PRODUCT SERVICE BULLETIN

Bulletin Number: PSB 01-2015

Subject: Vigil Cutters manufactured March 2015 – July 2015
(03/2015 – 07/2015)

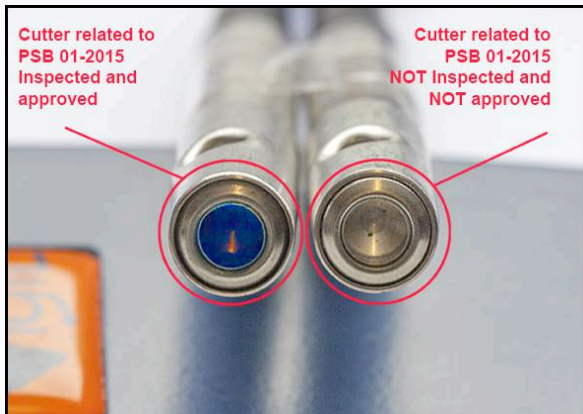
Upon investigating a report of a severed closing loop, it was determined that a rough edge inside the cutter abraded the loop fabric, causing it to fail.

Inspection of other cutters revealed a limited range of cutters which could potentially have rough edges inside. Subject cutters appear to be more likely to abrade the closing loop in equipment where the cutter is placed above the pilot chute. We do not expect to find that every cutter in this range of cutters has an issue, but in the interest of safety we are requiring that every cutter in this range be inspected.

A.A.D. nv/sa has determined that all cutters identified as having been produced during the specified date of manufacture range (3-15, 4-15, 5-15, 6-15 and 7-15) (mm-yy), whether or not they are installed in a harness-container-AAD system, must be recalled for in-house microscopic inspection at A.A.D. nv/sa, and that all reserve container closing loops with which a subject cutter was used must be replaced.
